# Access Compliance Report

## Public Rights-of-Way

Intersection ID: N/A	Main Street: MONROE_RD	Cross Street: KNICKERBOCKER_DR	Location: SE
ADA ID: 1BE35574A615	Ramp Type: Directional1	Initial Pass/Fail: Fail	Overall Compliance: No
Severity Score: 12.5			
Codes/Mitigation Info/Possible Solution		Field Measurements/Component Compliance

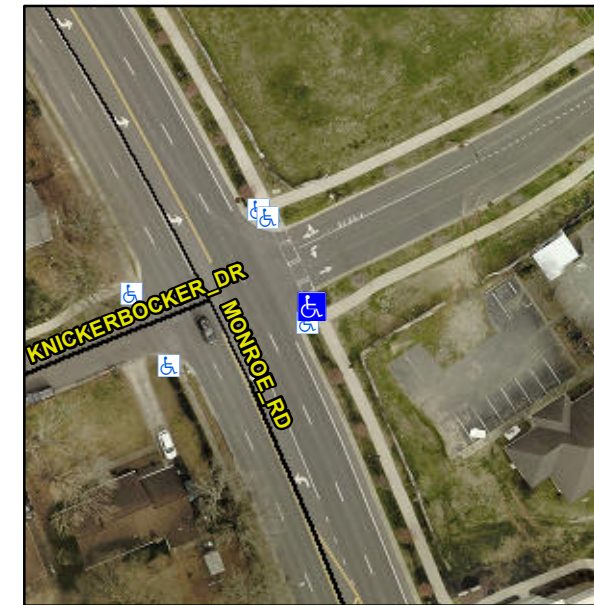
Compliance	Description	Data	Compliance	Description	Data
N/A	Ramp Length (in)	79.0	N/A	Grade Break?	N/A
Yes	Ramp Width (in)	65.0	N/A	Grade Break Slope (%)	0.0
No	Ramp Slope (%)	9.7	N/A	Grade Break XSlope (%)	0.0
Yes	Ramp XSlope (%)	1.0			
N/A	Flare Type LT	N/A	N/A	Flare Type RT	N/A
N/A	Flare Slope LT (%)	N/A	N/A	Flare Slope RT (%)	0.0
N/A	Flare Traversable LT?	N/A	N/A	Flare Traversable RT?	N/A
N/A	Landing Length (in)	0.0	N/A	DWS Provided?	N/A
N/A	Landing Width (in)	0.0	N/A	DWS Contrast?	N/A
N/A	Landing Slope (%)	0.0	N/A	DWS Length (in)	N/A
N/A	Landing X Slope (%)	0.0	N/A	DWS Full Width?	N/A
N/A	Landing Curb? (Y/N)	N/A	N/A	DWS Offset LT (in)	N/A
N/A	Shared Landing?	N/A	N/A	DWS Offset RT (in)	N/A
N/A	Gutter Ponding?	0.0	N/A	Gutter Slope (%)	N/A
N/A	Gutter Lip Ht (in)	0.0	N/A	Gutter X Slope (%)	N/A
N/A	Painted X Walk1?	Yes		Road Slope (%)	0.4
	X Walk 1 Direction	To NW		Road X Slope (%)	1.0
	X Walk 1 Width (in)	70.5		Clear Space?	N/A

**Remove & Replace Entire Ramp.**

**R304.2.2**
